STATEMENT OF EXPERT EVIDENCE

**CITY OF GREATER GEELONG
PLANNING SCHEME AMENDMENT C259**

**ARMSTRONG CREEK
HORSESHOE BEND PRECINCT**

**STORM WATER MANAGEMENT
STRATEGY (SWMS)**

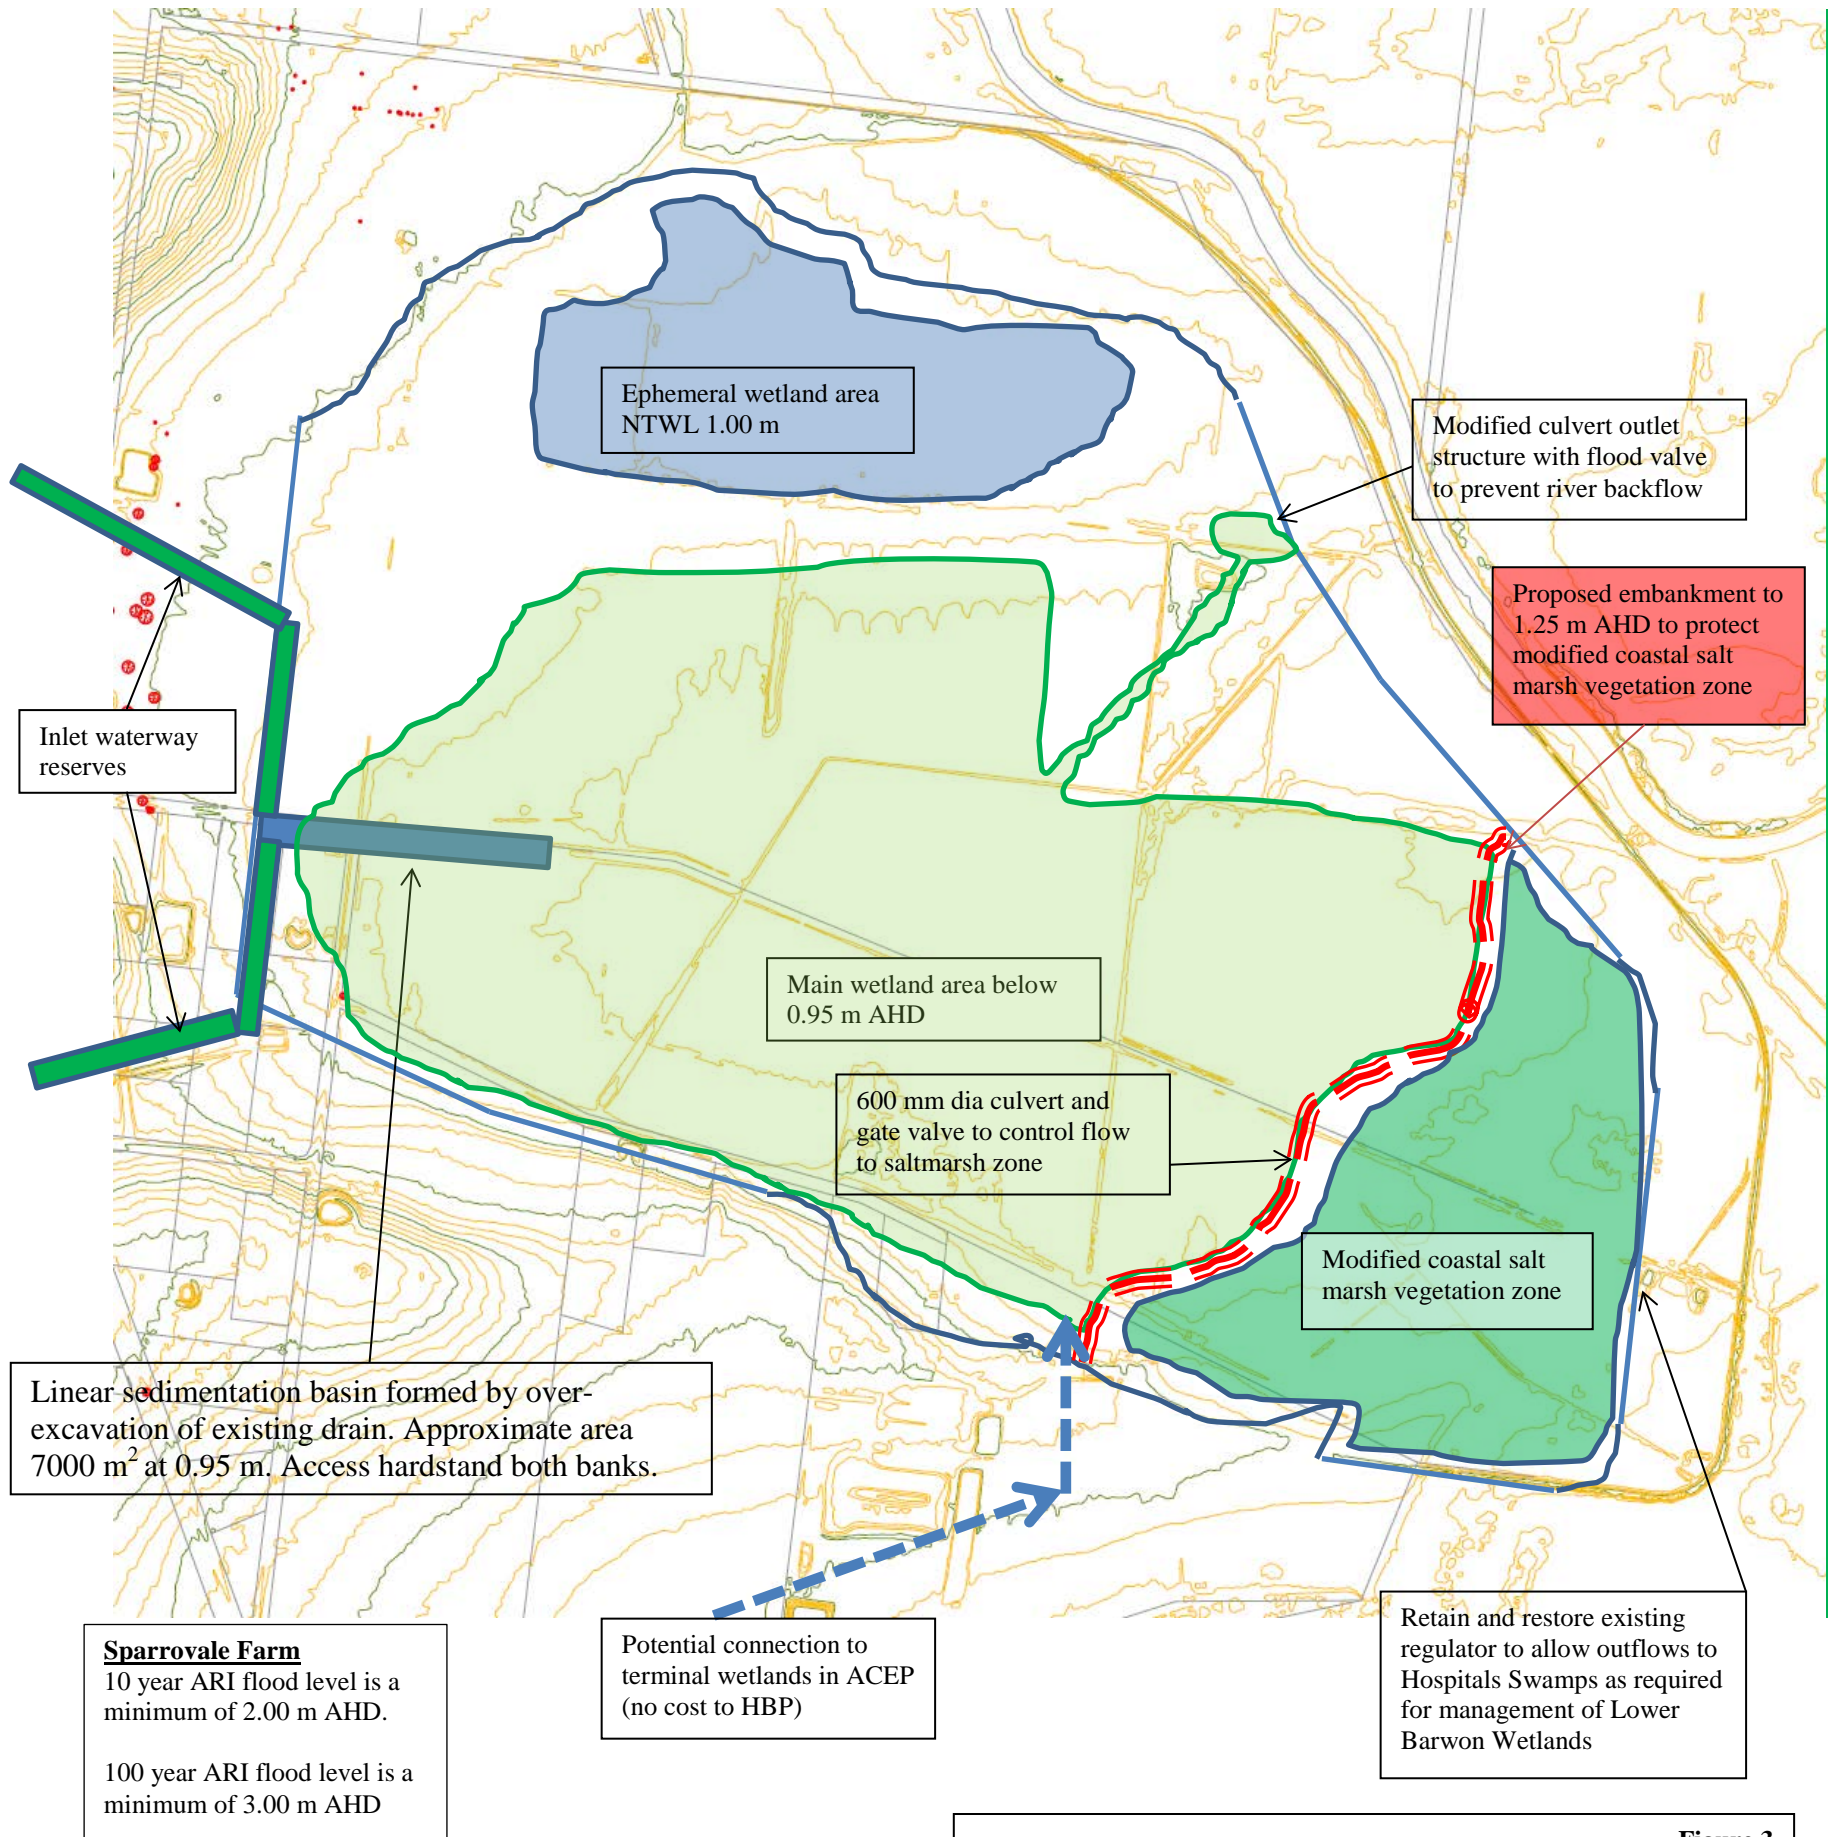
Appendix 1 of our report dated 20 May 2014 reviewed the DCP DI_DR_13 cost estimates. Whilst the quantities, rates and costs listed in the DI_DR_13 summary table are considered generally appropriate, it is suggested that some changes could be made for Items 2.2, 2.3, 3.3, and 5.1, 5.2 and 5.3 as set out below.

DI_DR_13 Item	Issues of concern	Discussion
2.2 and 2.3	<ul style="list-style-type: none">• Inspection and aerial photos indicate no large surface rubbish stockpiles are evident across the lowest parts of the properties.• Imported fill stockpiles appear to be mainly around the higher margins.• Estimates are high and appear to allow for offsite removal.	<ul style="list-style-type: none">• Given the vast size of the site there is no reason why rubbish and contaminated fill cannot be disposed of onsite in landscape mounds or levee berms.• Audit costs OK but contamination treatment costs are likely far too high.• Should be a PC item subject to audit outcomes.

DI_DR_13 Item	Issues of concern	Discussion
3.2	<ul style="list-style-type: none"> • Existing levee may be largely abandoned after hydrodynamic review completed. As a minimum repair/rebuild works on existing levee will be required on Barwon River frontage. 	<ul style="list-style-type: none"> • Should be a PC item after completion of hydrodynamic modelling review.

3.3	<ul style="list-style-type: none"> • Very high estimate for very low level works requirement within Sparrovale. 	<ul style="list-style-type: none"> • Other than the inlet sediment basin itself (which will be a Council asset to manage into the future) there is no requirement for sediment removal across the general Sparrovale wetlands area now or for many decades into the future. • The inlet basin itself should not require sediment clearing within 5 years after its construction, because of the upstream sediment management assets. It is unlikely to be built within 5 years. • Maximum \$50,000 over 10 years.

5.1	<ul style="list-style-type: none"> • Duplicates initial audit • Way too high given full repair of the levee will be carried out at the start and then only if need is confirmed after hydrodynamic modelling review. Partial repairs/rebuild may only be required on the Barwon River frontage. • Any major flood damage repair required thereafter will not be a DCP item. 	<ul style="list-style-type: none"> • Suggest biannual visual inspection (plus a check after floods) is all that is required for the final design levee systems. • Say \$25,000 total over 10 years.

5.2	<ul style="list-style-type: none"> • Estimate too high • \$10,000 initial first assessment is part of initial management plan and flora and fauna assessment. • Follow-up assessments should be 2 years afterwards, then at 5 years and 10 years. 	<ul style="list-style-type: none"> • Suggest \$30,000 total over 10 years.

5.3	<ul style="list-style-type: none"> • Conflicts with recommendations of water quality monitoring program we have supplied. • Estimate is too high. 	<ul style="list-style-type: none"> • Short term need (say years 1-5) for Sparrovale is one site only at existing outlet. \$5,000 in year 1. For years 2-9 this site should be \$2,500/year. Total \$27,500 for 10 years. • In years 5-10 two extra sites come online in Sparrovale. Assume both online at end year 5. • The wetland inlet site is \$15,000 for the 5 years. • Ditto for the Barwon outlet. • Total \$57,500-say \$60,000 for 10 years.
